Response to Reviewer 2.

The authors present a comprehensive evaluation of the ocean biogeochemical components of 6 CMIP5 models against observed APO and Satellite estimates of phytoplankton productivity. The goal here is to offer the APO datasets, in particular, as a new constraint on the models. The authors use a transport matrix method so as to speed the process of atmospheric transport substantially. They compare this method to a direct method and only consider regions where this works well. Atmospheric transport uncertainty is smaller than variance across the ocean biogeochemical models for the high latitude sites. This is important, since the utility of APO has generally been questioned by the fact that one must do this transport calculation. The authors could point this out more clearly, i.e. in conclusions. On the whole, this is a nice analysis that should be published after minor revisions.

New Figure 1

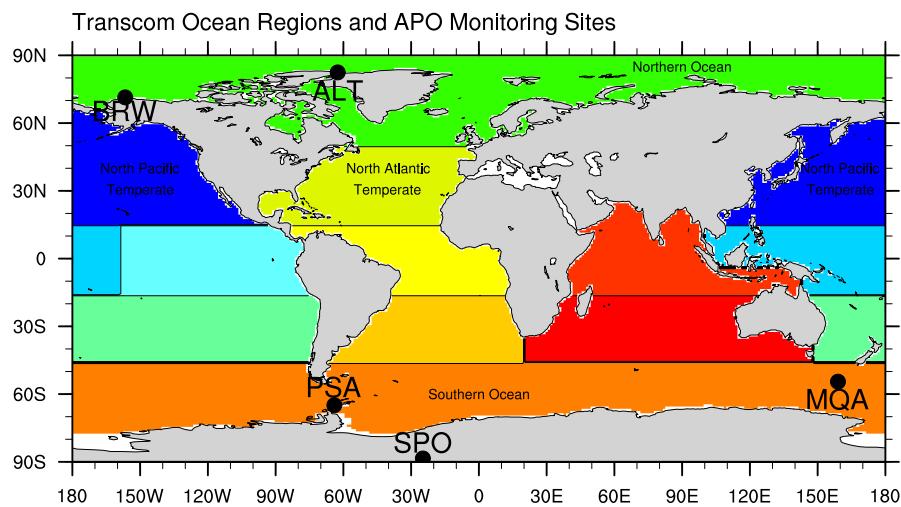
Major comments: 1. The transport matrix is a good step, and I support its use for this paper. Going forward, the authors might consider developing such a matrix approach based on regions different from the square boxes of TRANSCOM that do not capture the biogeography of the ocean well. Fay and McKinley (2014) offer global biomes that would be preferable. For this paper, the authors need to clarify if the aggregation across these square biomes could impact their results and the model-to-model differences that are found. Specifically, if models don't have their major biogeochemical gradients across the TRANSCOM region boundaries, could this influence these comparisons? I also ask that TRANSCOM region boundaries be included in at least one panel in Figure 4. Fay, A. R. & McKinley, G. A. Global open-ocean biomes: mean and temporal variability. *Earth Syst. Sci. Data* 6, 273–284 (2014).

We agree with Reviewer 2 that the latitude-based boundaries of Transcom3, which we now show in our new Figure 1, are not ideal for capturing the main biogeochemical boundaries. The biomes defined in Fay and McKinley, 2014 would likely be an improvement, and the partitioning of the Southern Ocean into 3 different regions based on biogeochemical function, could provide insight into the contribution of these different regions to variability in APO. While it is beyond the scope and resources of the present study to rerun the T3L2 basis functions to create new biome-oriented basis functions, we now discuss the advantages of this strategy in the following text added to the Discussion,

“In addition, the spread in ATM results has been reduced substantially for CO₂ inversions using post-Transcom3-era ATMs [Peylin *et al.*, 2013], suggesting that ATM uncertainty also may be reduced for forward simulations of APO. If this is the case, then new forward simulations with several different modern-era ATMs may be sufficient to characterize ATM uncertainty. Alternatively, it may be valuable to continue with a matrix-based approach, using basis functions from many ATMs, but with redefined regional boundaries that are not defined based simply on latitude, as in T3L2 (Figure 1), but rather that correspond to the biogeography of major ocean regions [Fay and McKinley, 2014]. The definition of such basis functions could help extend the utility of the matrix approach to lower latitude APO monitoring sites and allow for the partitioning of the Southern Ocean into multiple regions defined around biogeochemical function, while still retaining the advantages of the matrix method, i.e., the ability to quickly and easily compare multiple ATMs forced with the same air-sea fluxes.”

p. 8517 we have added a new Figure 1 showing both the Transcom regions and the locations of APO stations featured in Figure 2 (see above).

New Figure 4 (formerly 3), partitioning APOncp, APOtherm and APOvent at Barrow.

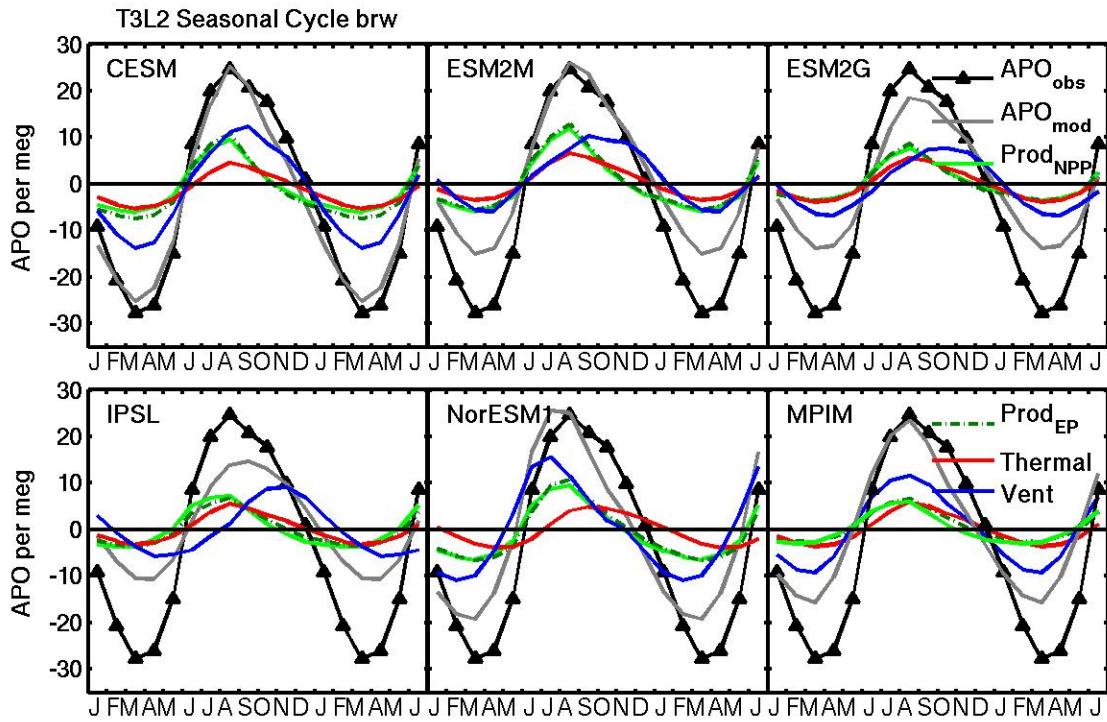
2. It is unfortunate that the Ventilation and NCP signals cannot be distinguished; and at the same time the NCP estimates from satellite are so uncertain that we have a reasonably loose constraint here. Showing the APO_{vent} estimated as a residual would be helpful in Figure 3 to add to the text discussion and to better highlight this issue.

We now include the APO_{vent} term in Figure 4 (at Barrow, AK), while including caveats that, “APO_{vent} can be estimated only as a residual of 3 other terms using standard CMIP5 output and thus its shape and phasing are sensitive to even small uncertainties in those other terms. Thus, the residual ventilation curves in Figure 4 should be interpreted with caution (e.g., the NorESM1 curve is clearly unreasonable in phasing).”

At the end of Methodology Section 2.2.3 we also have added text to clarify the rationale for considering APO_{NCP} in the Southern Ocean while avoiding APO_{vent} , “While the problems with APO_{vent} necessarily imply a corresponding problem in one or both of the other component terms APO_{NCP} and $\text{APO}_{\text{therm}}$, as discussed below, the shape of these latter terms is still informative and is less sensitive to the uncertainties inherent in the residually-estimated APO_{vent} term.”
